STATE OF WASHINGTON
DEPARTMENT OF ECOLOGY

February 23, 2009

Subject: Potential Water Quality Conditions Associated with a Dredged Lake Alternative

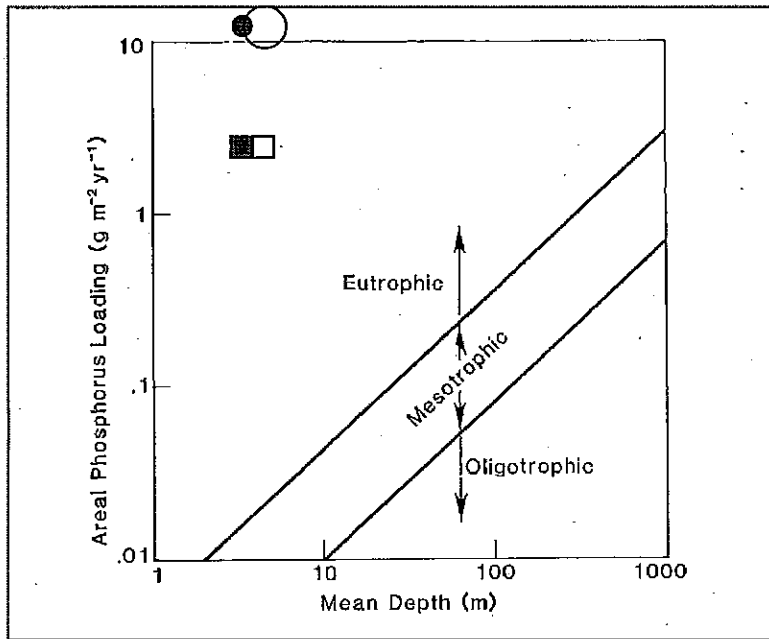
Figures 1 and 2 plot values for the annual and summer loading rates against the depth or depth normalized by residence time. For both the current and dredged lake alternatives, the combination of phosphorus loading and lake geometry plots well into the eutrophic zone of both figures. Figure 1 shows the proposed increase in water depth associated with dredging produces only a small shift to the right. The dredged lake alternative would still fall well into the eutrophic range, either for the annual loading or for only the summer loading rate. Because the depth increase would produce an offset in residence time, the only shift occurs due to rounding values in the calculations.

Without reductions in the areal phosphorus loading rate, the lake depth would need to be >100 m to fall into the mesotrophic range in Figure 1. With the proposed nominal depth of 14 ft (4.0 m), the annual areal loading rate would need to be reduced one to three orders of magnitude to achieve the mesotrophic range.

Figure 2. Vollenweider's (1975) phosphorus loading plot to include the residence time with trophic state. The solid circle represents annual values for current conditions and the open circle represents the dredged lake alternative. Source: Reckhow and Chapra (1983).

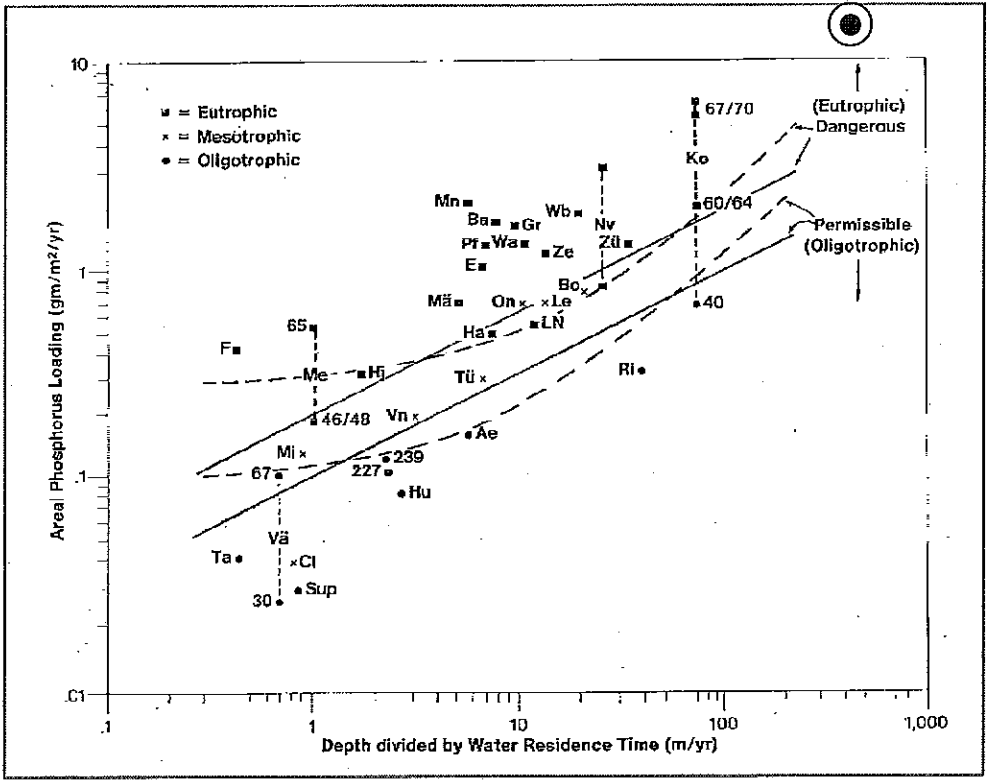
Vollenweider's areal loading analyses were based on loads from the watershed. However, total phosphorus fluxes from the sediments also are significant. Sediment fluxes vary over time, but the highest fluxes often coincide with warm temperatures and high pH values within the lake. The mean nutrient flux used in the Capitol Lake model is 1.6 g/m²/yr, which is well into the eutrophic range of Figure 1 for all but the deepest lakes. If residence time is considered, sediment fluxes alone (1.6 g/m²/yr and 334 m/yr) would plot in the middle of the mesotrophic range in Figure 2. The combined sediment and watershed nutrient fluxes plot in the eutrophic range of Figure 2.
